PSE: Dual-signature SM Class Probe, Class Reset

DAVID STOVER

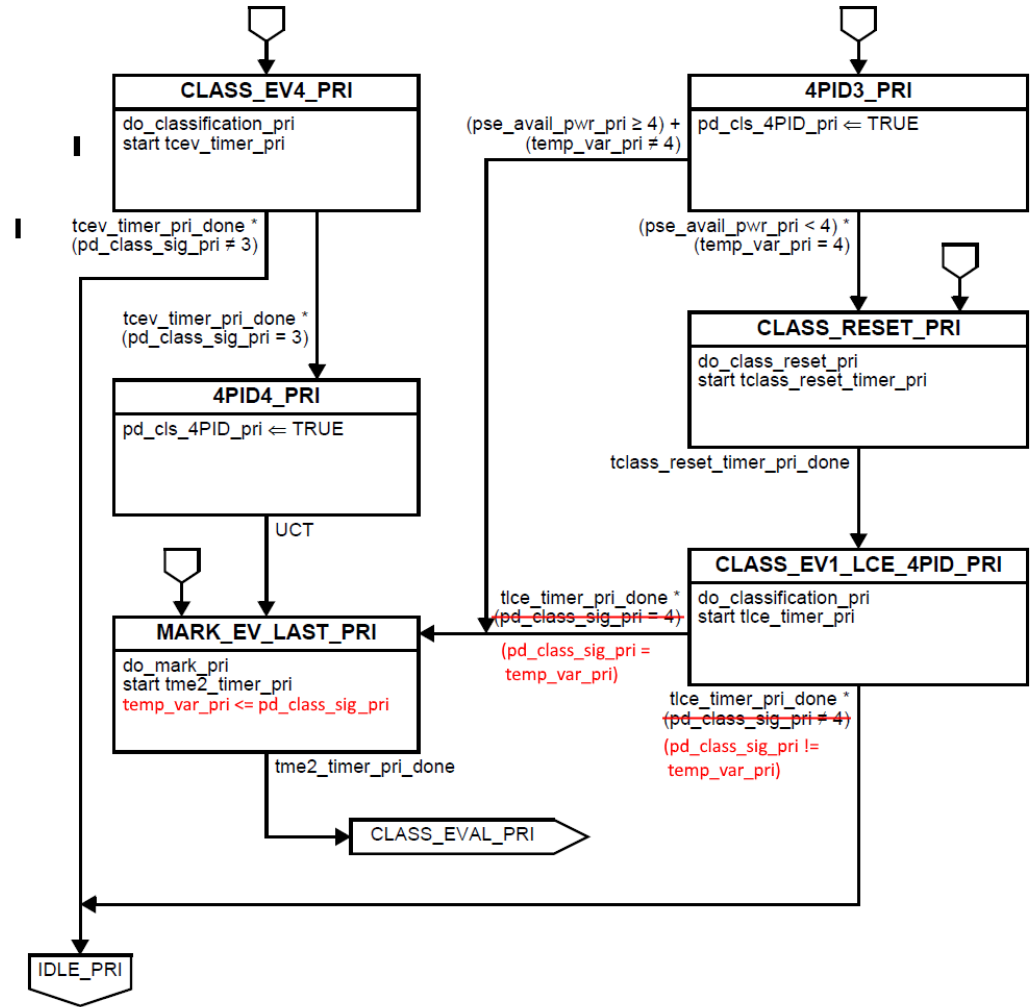
Problem Statement

- ▶ In SISM, Class Reset double-checks `pd_class_sig`
 - Ensures PD class signature has not changed since CLASS_EV1
- ▶ In Draft 3.0, Class Reset only performed if `pd_class_sig = 4` in CLASS_EV1
- ▶ In Draft 3.1, Class Probe uses Class Reset function
- ▶ With Class Probe, Class Reset may be performed for `pd_class_sig = 1` to `4`

- ▶ Modify Figure 145–15 as shown
- ▶ Repeat for Figure 145–16
 - “SEC” state diagram
- ▶ Note: temp_var_X holds pd_class_sig from CLASS_EV1_X
